Development Review Committee Comments | 1/2/2024 Case PLAT23-0056 Wayfarer Addition (6716 Stardust Drive)

WRITTEN STATEMENT OF CONDITIONS

PRELIMINARY PLAT WAYFARER ADDITION

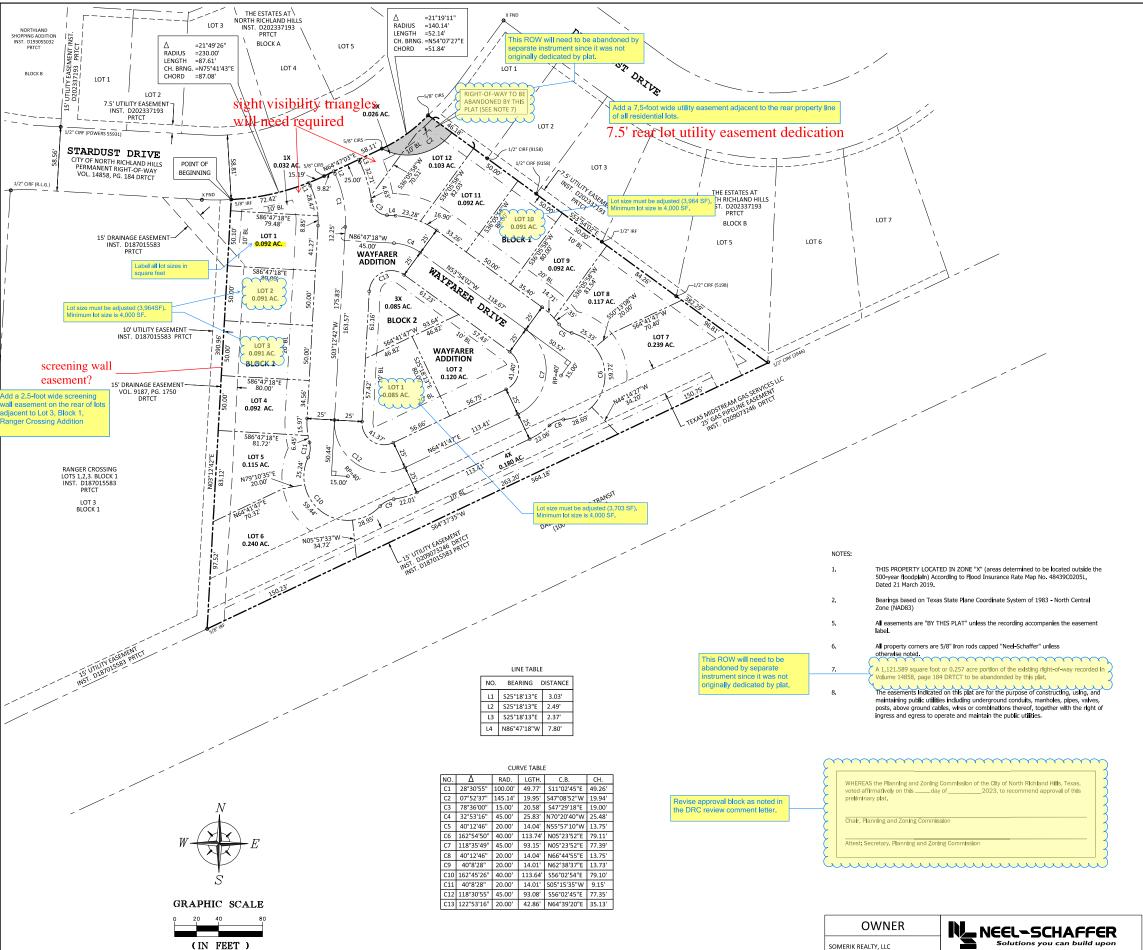
- Removing the email address for the owner from the plat is recommended since the plat is a recorded public document. NRH Subdivision Regulations §110-331 (Requirements for all plat drawings – ownership/developer)
- 2. The County clerk recording block may be removed from the drawing. Preliminary plats are not recorded, and the block is not necessary. NRH Subdivision Regulations §110-333 (Additional requirements for plat drawings county certification)
- 3. Revise the Planning and Zoning Commission approval block on the plat as follows. The block below is specific to preliminary plats. NRH Subdivision Regulations §110-333 (Additional requirements for plat drawings planning division approval certification)

- 4. Remove the 10-foot rear building line from the residential lots. NRH Subdivision Regulations §110-331 (Requirements for all plat drawings building setback lines)

- 5. Remove building lines from lots 1X and 2X Block 1. These are open space lots, and the building line is not necessary. NRH Subdivision Regulations §110-331 (Requirements for all plat drawings building setback lines)

- 6. Label all lot sizes in square feet rather than acres. NRH Subdivision Regulations §110-333 (Additional requirements for plat drawings lot areas)
- 7. Lots 2, 3, and 10, Block 1, and Lot 1, Block 2 do not meet the minimum lot area of 4,000 square feet required by the property zoning. Revise the lots accordingly. NRH Subdivision Regulations §110-412 (Design criteria lot dimensions)

- 8. Add a 2.5-foot wide screening wall easement on the rear of lots adjacent to Lot 3, Block 1, Ranger Crossing Addition. NRH Subdivision Regulations §110-331 (Requirements for all plat drawings easements)

- 9. Provide sight visibility easements (15 ft by 70 ft) on both sides of the corner of Stardust Drive and the new roadway connection. NRH Zoning Ordinance §118-714 (Visibility sight triangles)

- 10. Add a 7.5-foot wide utility easement adjacent to the rear property line of all residential lots. NRH Subdivision Regulations §110-331 (Requirements for all plat drawings easements)

- 11. The proposed right-of-way abandonment for Stardust Drive must be done by separate instrument. The right-of-way was originally dedicated by deed and not by plat. Provide a separate exhibit and metes and bounds description of the area. The abandonment will be processed as part of the final plat application. NRH Subdivision Regulations §110-368 (Street right-of-way dedication)

The County clerk recording block

drawing, Preliminary plats are not

ecorded and the block is not

may be removed from the
